# LAYTON TREE CONSULTING, LLC

## Trees & Construction Memo

To: Greg Arms  
From: Bob Layton  
CC:  
Date: July 8, 2025  
Re: 7621 SE 22<sup>nd</sup> ST – Lot 1 Tree Retention Issues – Tree #1

Subject tree

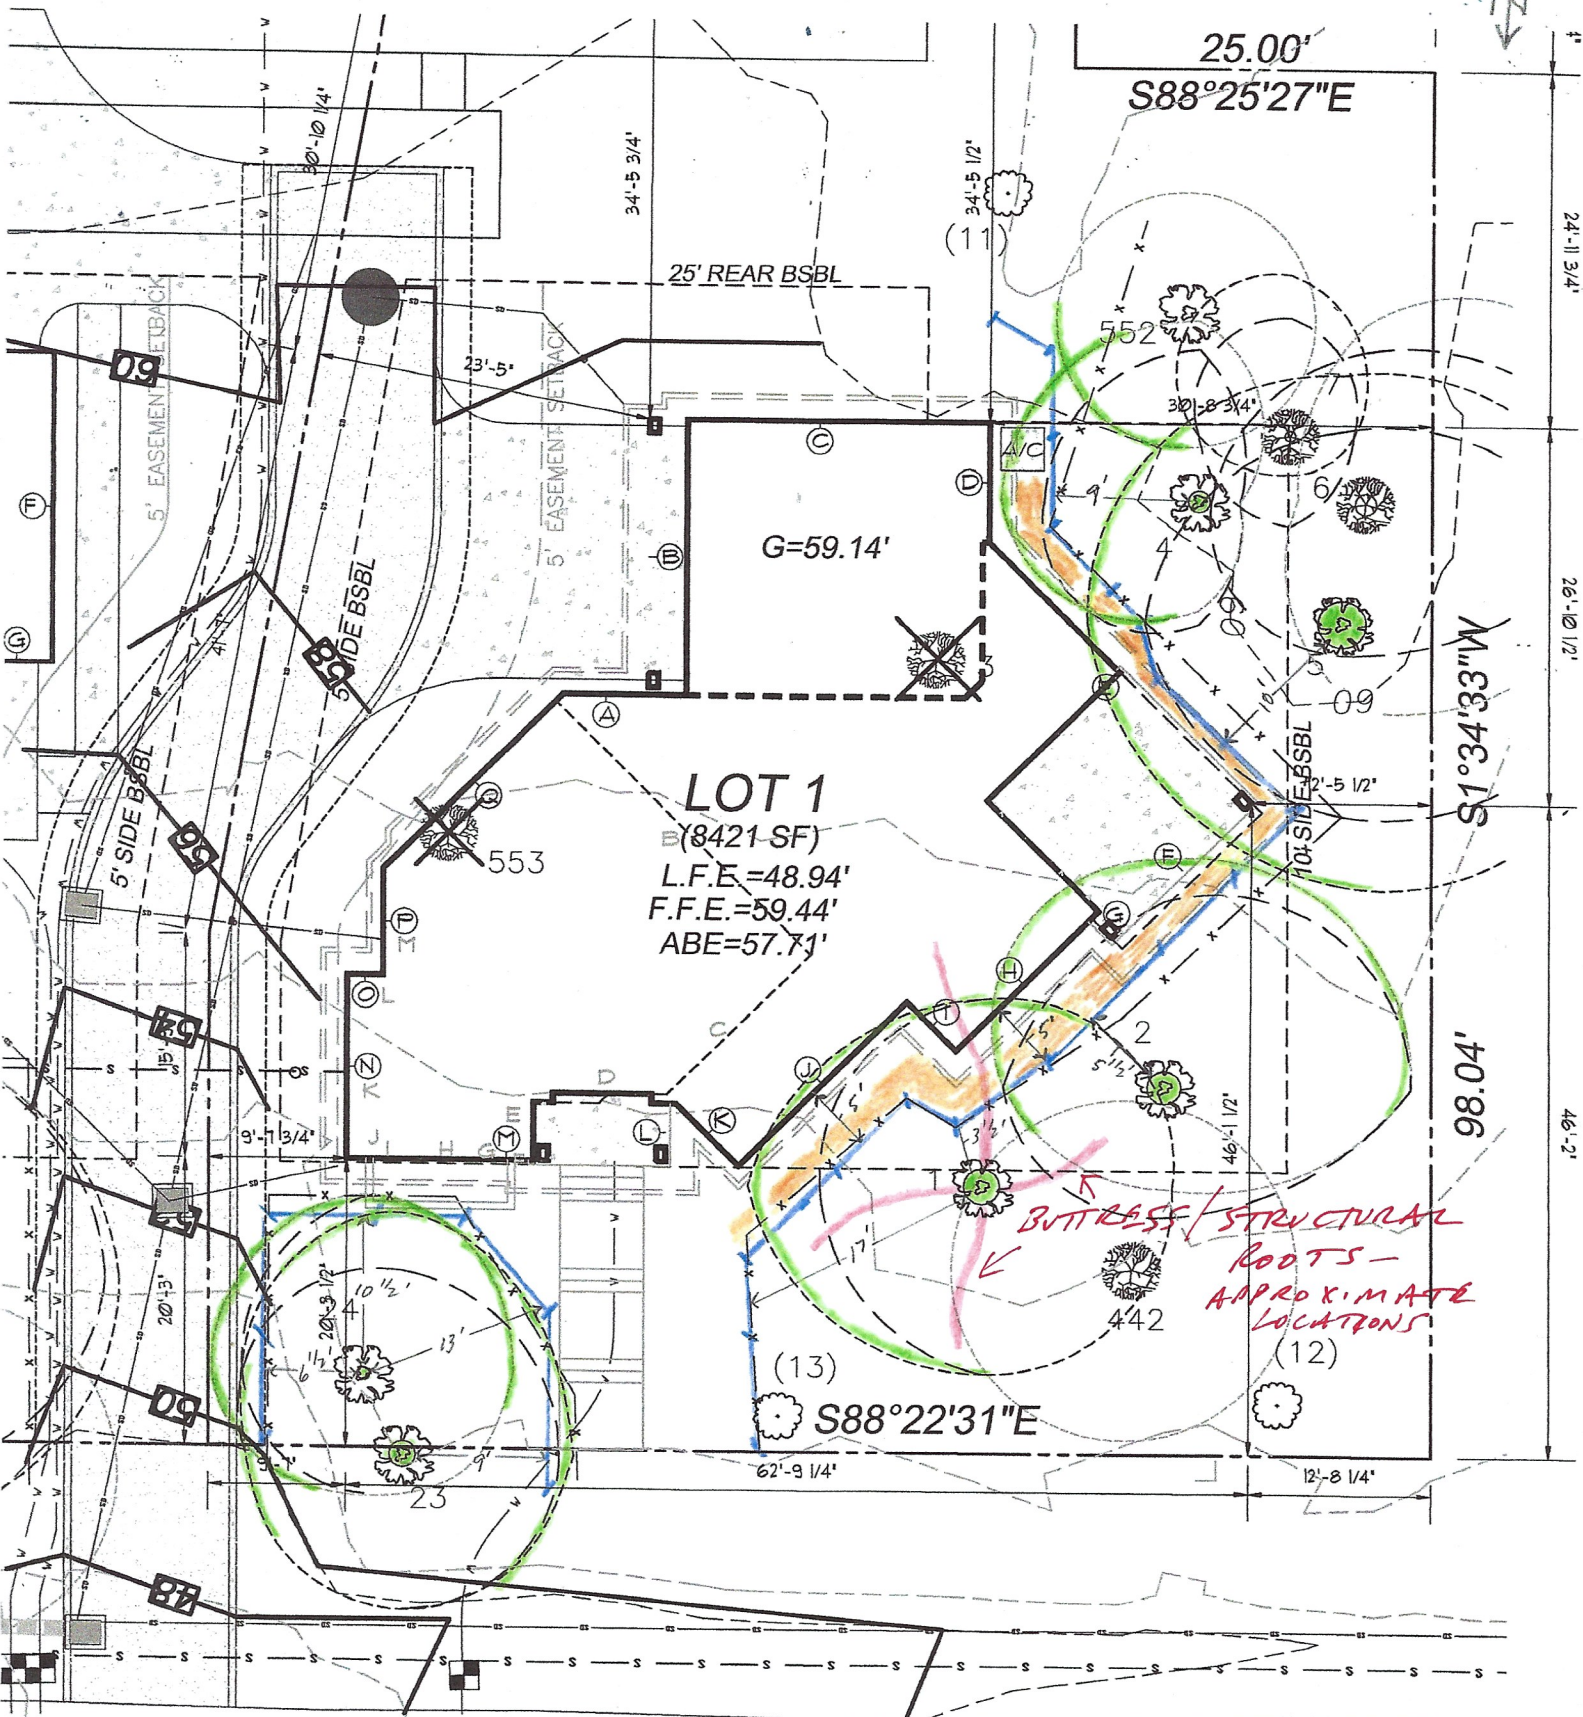
Unfortunately, there are issues with the continued retention of Tree #1, a 31-inch diameter Douglas fir. A large shallow structural root was exposed by the operator at roughly 18-feet from the trunk face on the south side during the excavation. The excavation needed for the approved house location or to facilitate the foundation construction will have to sever this root at 6-feet from the trunk face, see the attached exhibit.

Based on bulges at the root crown, the subject has only four buttress or structural roots. These basically radiate from the trunk in the four cardinal directions – north, south, east and west as shown on the attached exhibit. Once the south root is severed, there will be no supporting roots left on the south or windward side of the tree. Trees in the vicinity are very shallow-rooted. Based on the recent excavation work, roots only exist within about the top foot of the ground surface. There is a dense shallow hardpan layer, preventing roots from penetrating deeper into the ground.

I have concerns that if this root is cut, the trees' ability to remain standing when loaded by strong southwest prevailing winds may be in jeopardy. The subject is roughly 120-feet in height. The tree is well within the striking distance of powerlines and the neighboring houses to the north across SE 22<sup>nd</sup> Street. To abate the potentially hazardous condition, removal and

replacement is recommended. Three new Douglas fir trees could be planted in the vicinity to mitigate the canopy loss.
